Project Proposal

Property Address 309 E Fairy Chasm Road

Attention:
Village of Bayside, WI
Architecture Review Committee

<p>PROJECT/SITE OWNER: Matt Evans</p> <p>PROJECT ADDRESS: 309 E Fairy Chasm</p>	<p>PROJECT SUMMARY: New 8' X 12' shed</p>
---	---

Picture of Proposed
Shed

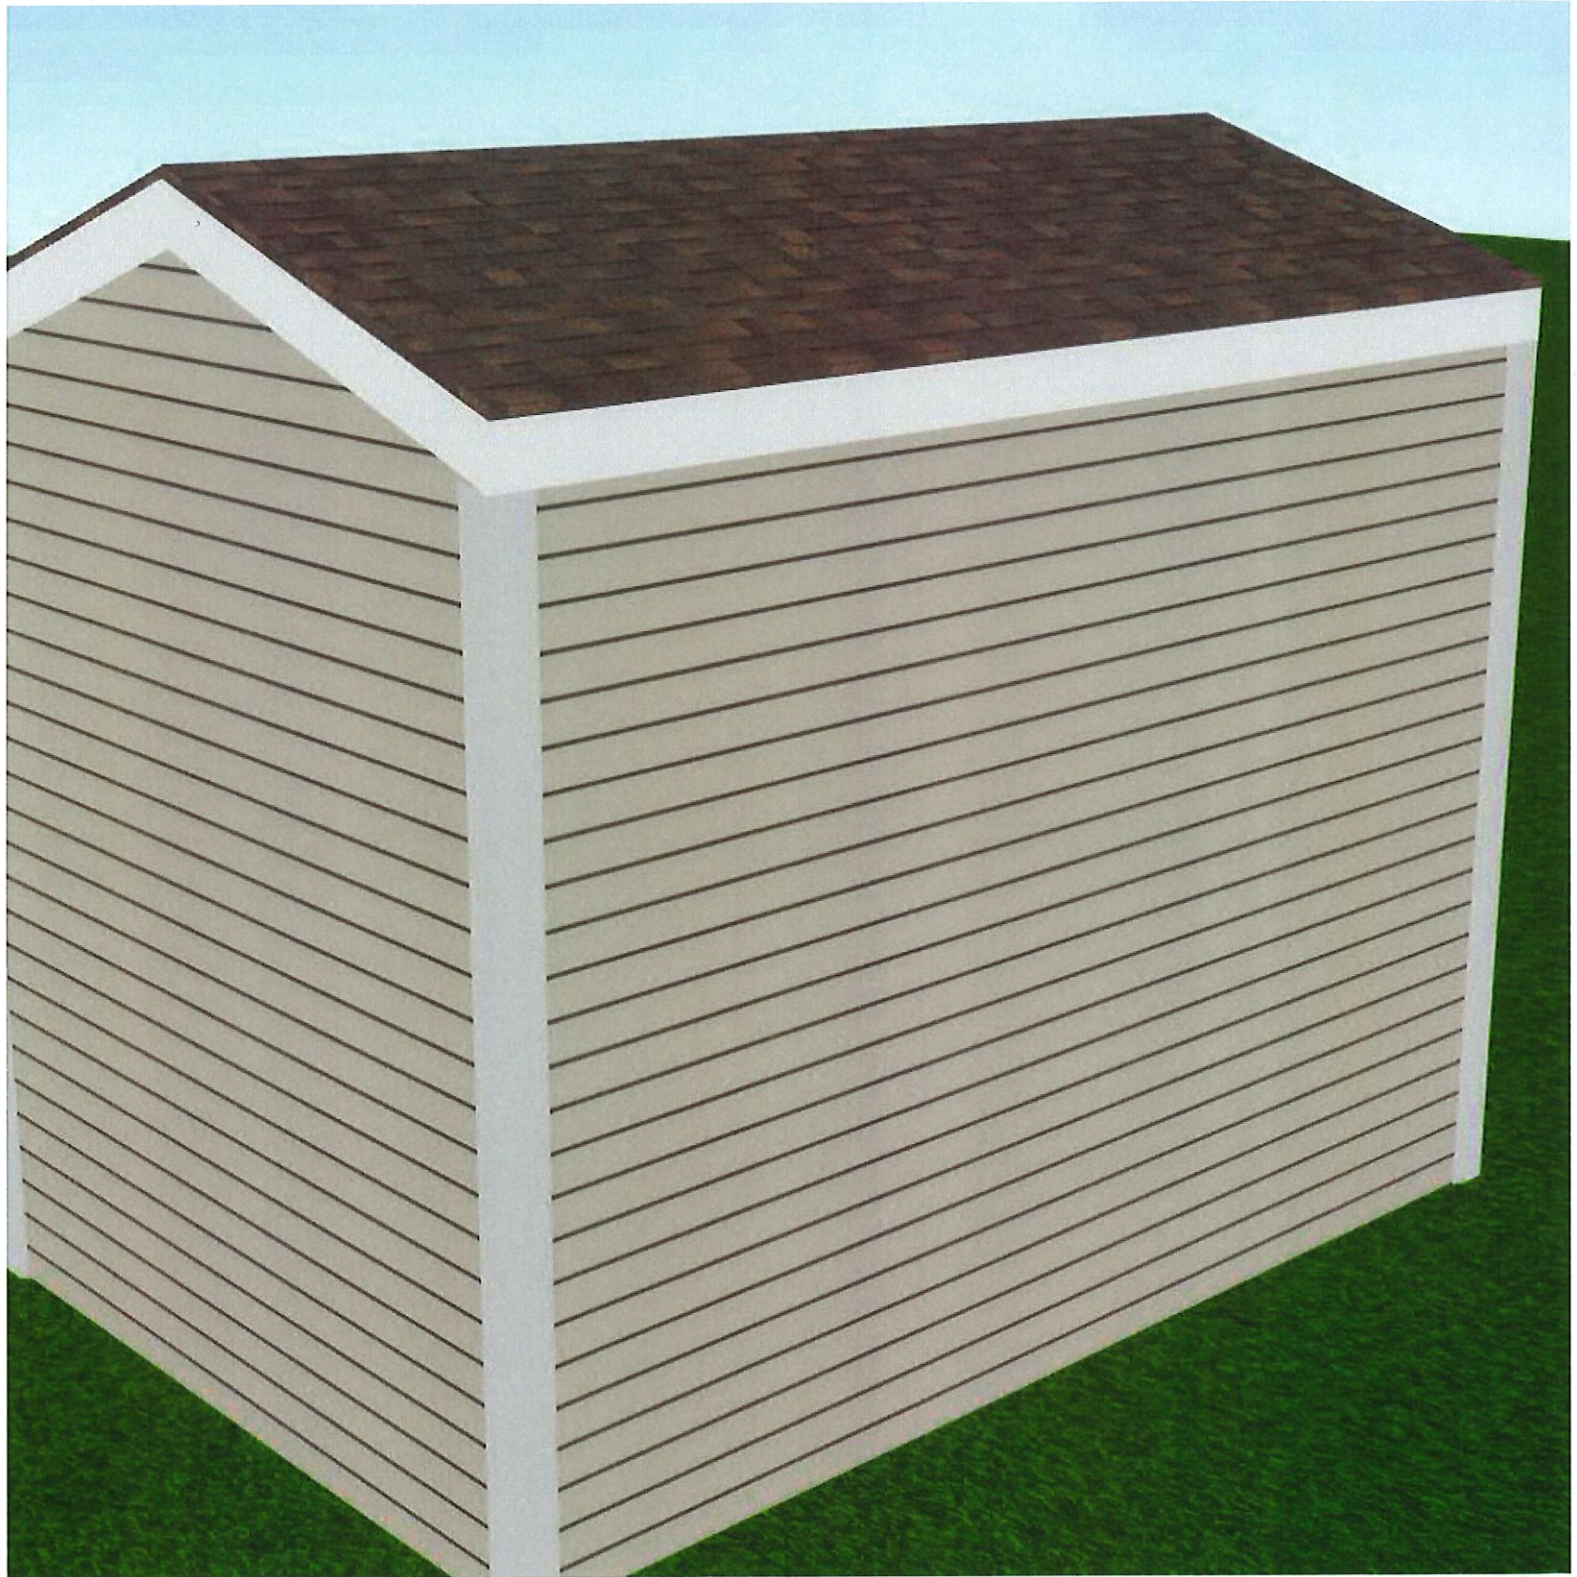
Reviewer believes this project complies with the following Village Code sections:

104-2(a)(2) Architectural Review Committee: *Construction and renovation should be made so that exterior architectural appearance shall be substantially consistent with structures already constructed in the immediate neighborhood, or with the character of the applicable district.*
